SERVICE BULLETIN No. L13/002

Subject: Locking of the rudder control cable against release.

Figure No. 1

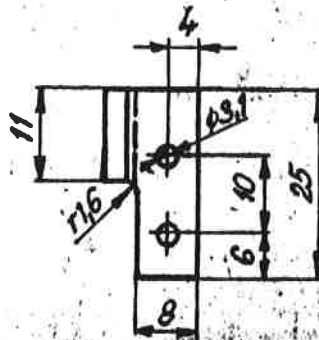
Reason: Original arrangement was not safe against falling down of the cable from pulley.

Description: Attachment of two brackets to the rudder rib No.1 to prevent falling of the cable from pulley.

1. Tilt the horizontal stabilizer.
2. Disassemble the rudder control cable at the front pedals and remove the rudder.
3. Position the bracket to Fig.2, make a thread M3 and attach by 4 bolts M3.
4. Reinstall the rudder and control cables to the front pedals.

Sharp edges deburred.

Extended length = 21 x 25mm

Material: 12 020.1

Surface protection: zinc coated

EH bracket shown - the EH bracket is a mirror image.
